Planning Decisions Committee

6.30pm, Tuesday 23 April 2024

1. This report provides the Planning Decisions Committee with an assessment of the application at No. 276 Lennox Street, Richmond for an amendment to the planning permit to increase the hours of operation, practitioner numbers and number of daily appointments.

Image 28: Artistic perspective of the development from the corner of Smith Street and Langridge Street looking east - the built form likely to be deleted / set back via condition overlayed in red by Council Officers

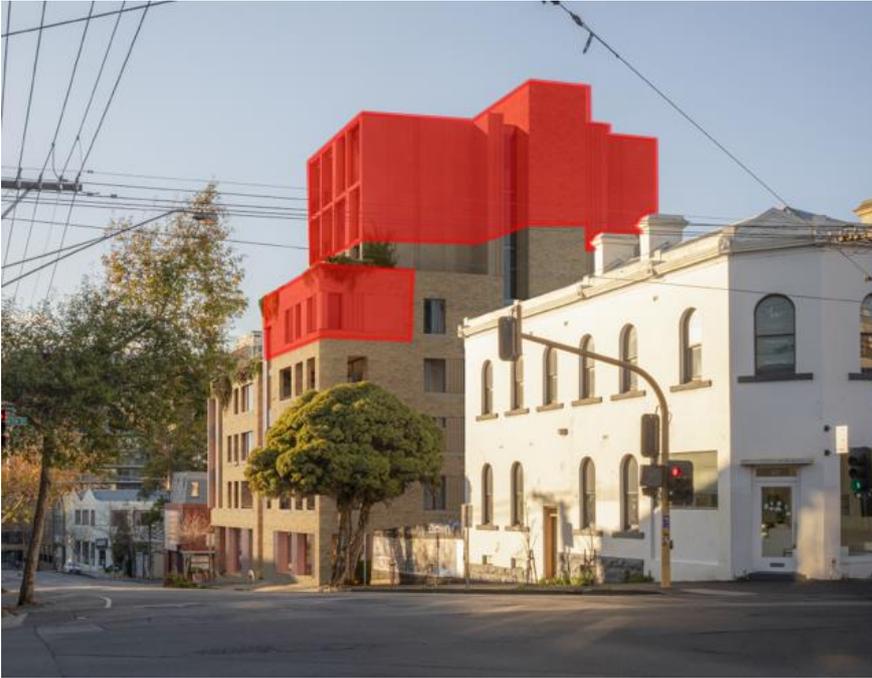
179. This will reduce the street wall to four storeys by providing a recessive form above the podium with a setback consistent with the setbacks of the upper levels from the western boundary (laneway), responding to the concerns raised by GJM consultants.

Image 30: Streetscape perspective of Derby Street from Façade and Materiality Development, altered by Council Officers to indicate an approximate height of 20 metres as recommended

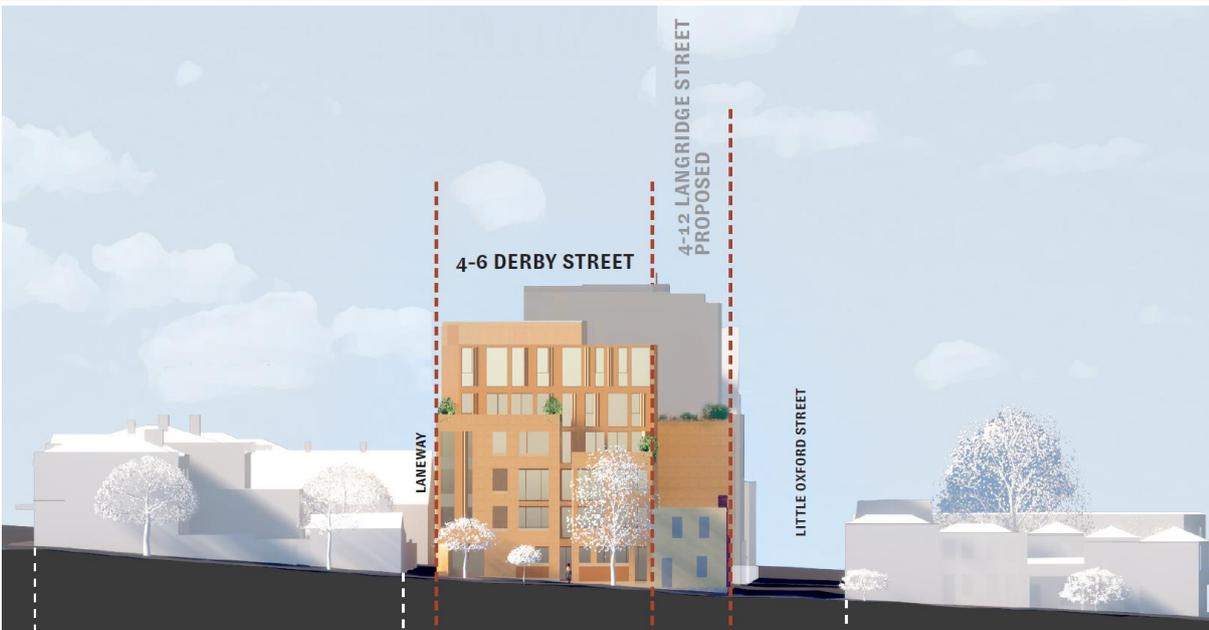
- (e) As will be established in the *Off-site amenity impacts* section of this report, the proposal subject to condition will not unreasonably impact the amenity of nearby residential development with regards to visual bulk, overshadowing and overlooking;

Image 31: Streetscape perspective of Langridge Street from Façade and Materiality Development, altered by Council Officers to indicate an approximate height of 20 metres and a four-storey street wall as recommended

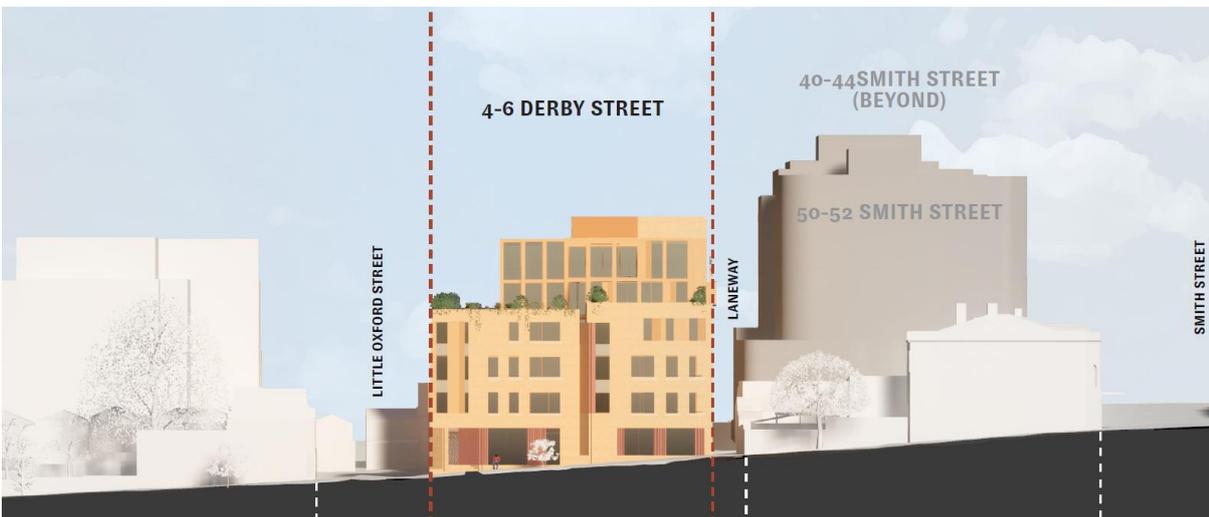
- (f) The greatest variations sought to the setbacks are on the north-west corner of the site (to Langridge Street). Subject to the recommended condition to set back Apartment 4.01 by 1.5 metres from the north and west boundaries, variations sought range from 2.95 metres to 4.5 metres from what is prescribed by the DDO23. However, due to the notable slope of Langridge Street and the generous separation from the building at No. 62 Smith Street, this variation to the setback will not result in the building dominating the adjacent heritage fabric. Further, the rear of No. 62 Smith Street may be developed in the future, restricting views to the upper levels from various vantage points. Finally, as submitted by Global South consultants, a variation to setbacks / podium height on the north-west corner will not have any adverse shadow implications;

Image 32: Excerpt of 1pm and 2pm shadows from TP28 – Decision Plans

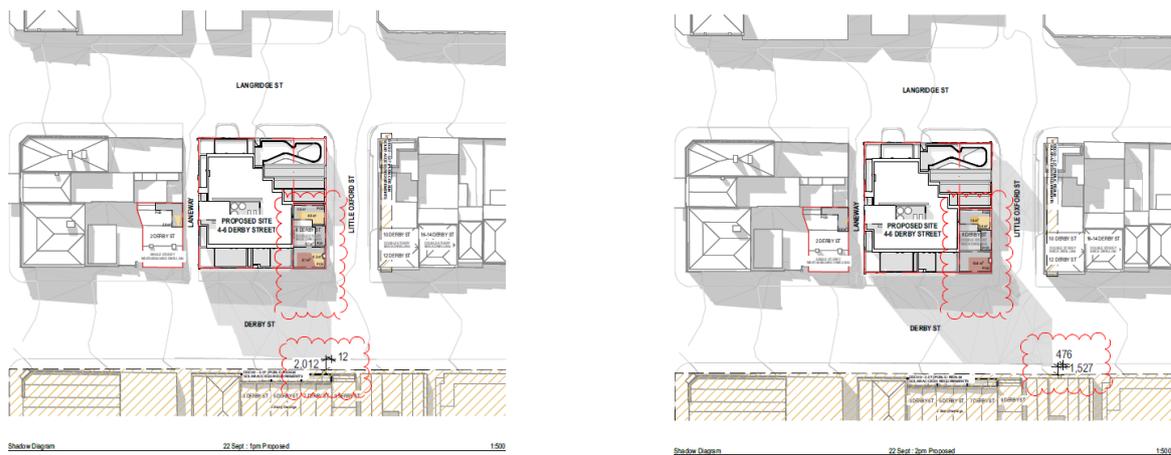
- 187. Schedule 23 to the DDO states that development must not overshadow any part of the southern footpath of Derby Street to a distance of 2 metres from the kerb between 10am and 2pm at the September Equinox. Council’s Strategic Planning Unit have clarified that in assessing an application against DDO23, the test for overshadowing should only have regard to the footpath, not the road formation.
- 188. Shadow diagrams are provided at TP28 which demonstrate that the development does not overshadow the opposite footpath (though falls very near to it at 1pm and 2pm) at the Equinox, thereby complying with the requirement.

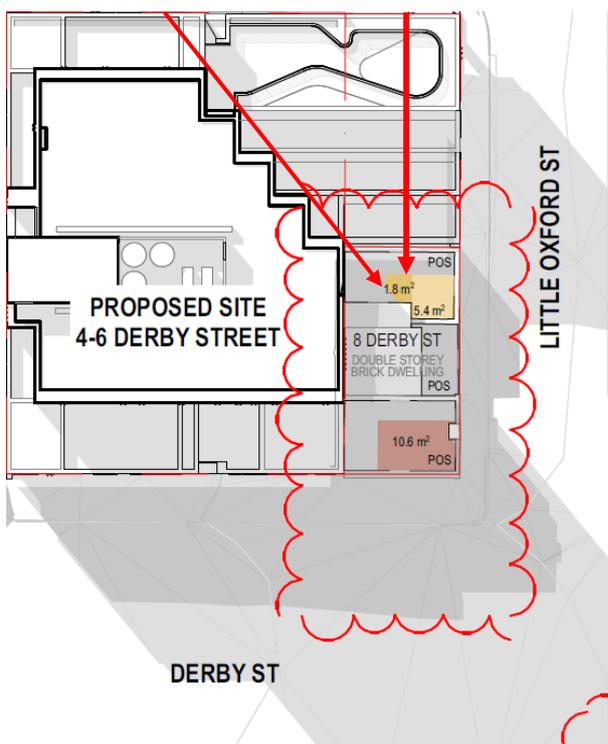
219. With regards to the shadow impacts to No. 8 Derby Street, the height of the proposed building would have to be substantially reduced, well below the heights prescribed by the interim or proposed DDO23, to avoid impacting the roof terrace located to the south-east of the development. Although the impacts to the southern roof terrace are notable in the afternoon, considerable effort has been made to mitigate the impacts to the northern terrace by chamfering the north-east corner of the tower and stepping the north-east podium down to a single storey. No. 8 Derby Street will have a good level of sunlight to one or both of the terraces throughout the day at the Equinox ensuring the dwelling is provided a reasonable level of amenity.

Figure 2 Little Oxford St Street Wall

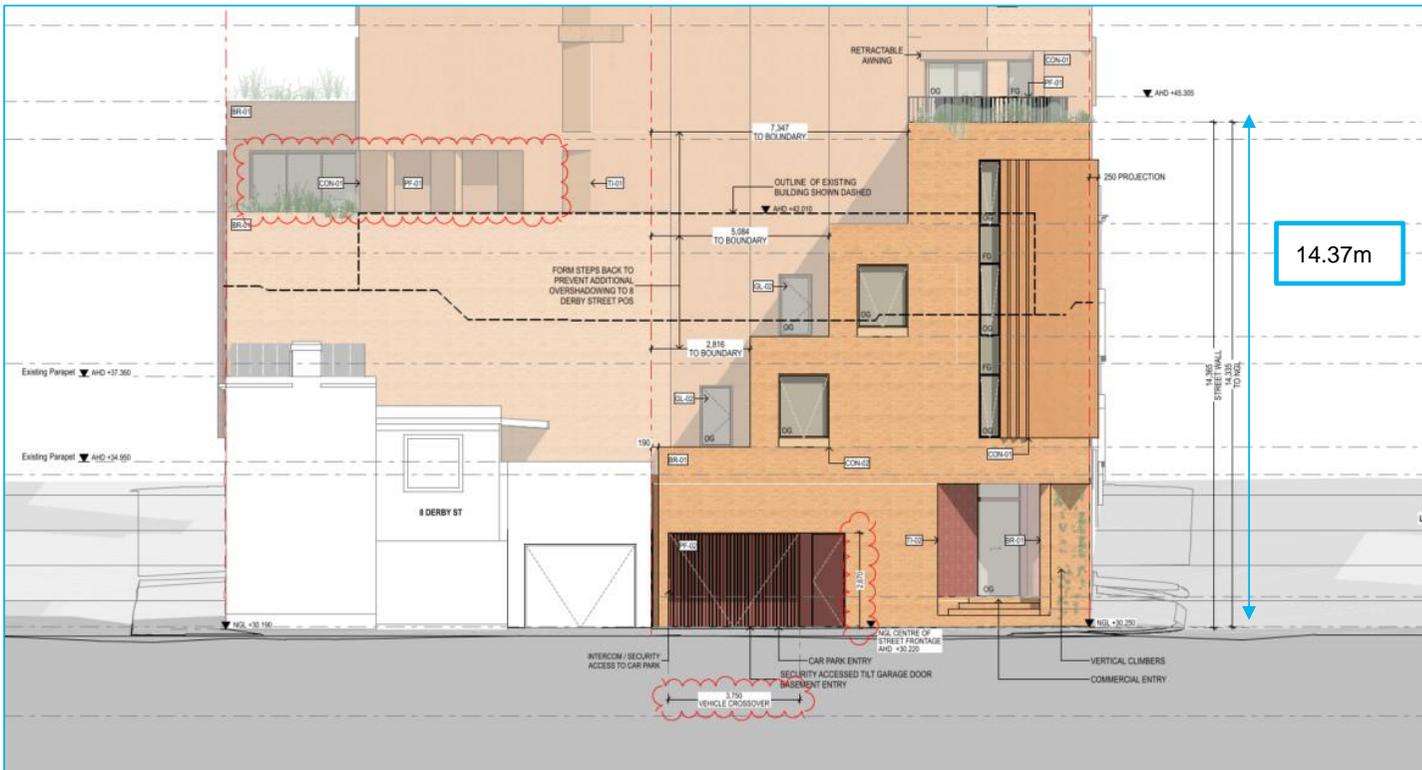
The street wall height varies on Little Oxford Street as shown in Figure 2. The tallest part of the street wall is 14.37m complying with the interim DDO however exceeding the proposed DDO by 3.37m.

It is considered that this variation should not be accepted given it does not meet the mandatory variation requirements. It is recommended that the street wall be lowered to meet the proposed requirement.

Figure 8: Sectional diagrams demonstrating shadow impacts to solar panels at June solstice and September equinox

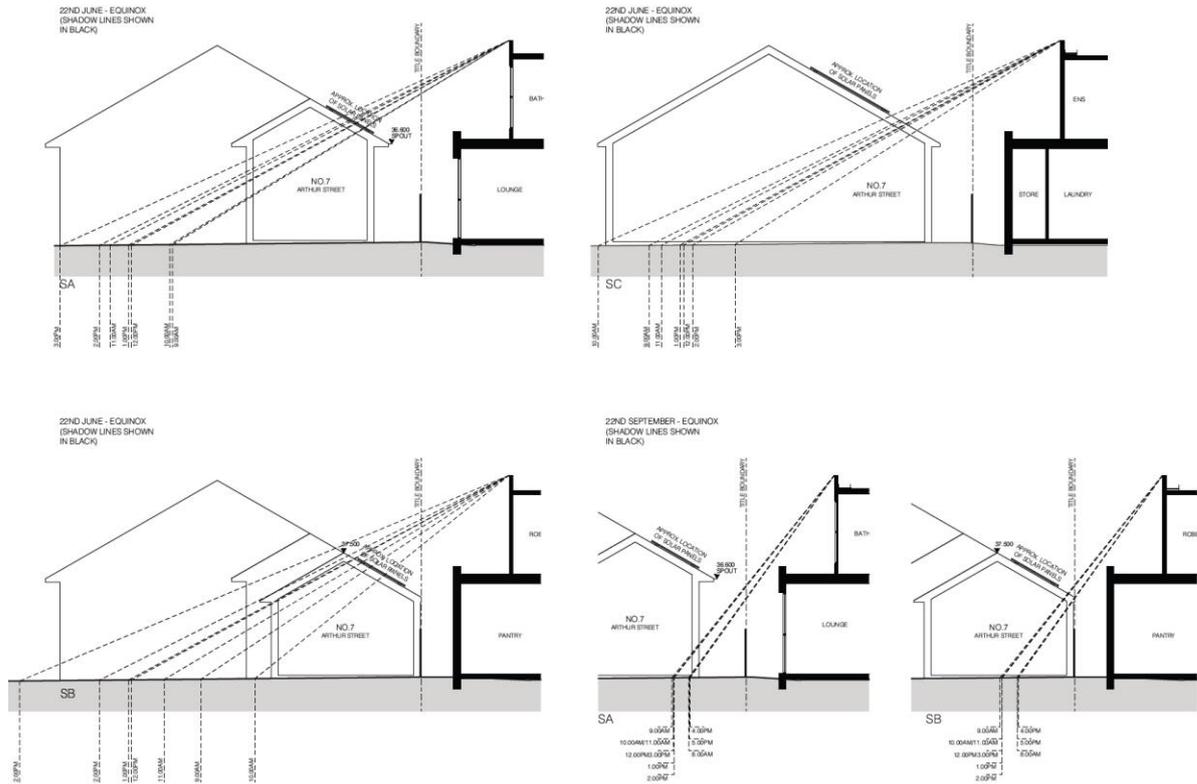
98. The extent that the adjoining solar panels at No. 7 Arthur Street are in shadow at the equinox is not considered unreasonable. The submitted shadow diagrams (Figure 8) confirm that the solar panels will not experience shadowing at the September equinox on any of the three separate solar panel sections. Shadowing will occur at the June solstice according to the shadow diagrams, however given the previous VCAT rulings on the matter, the September equinox has been used as the reasonable baseline in this instance.
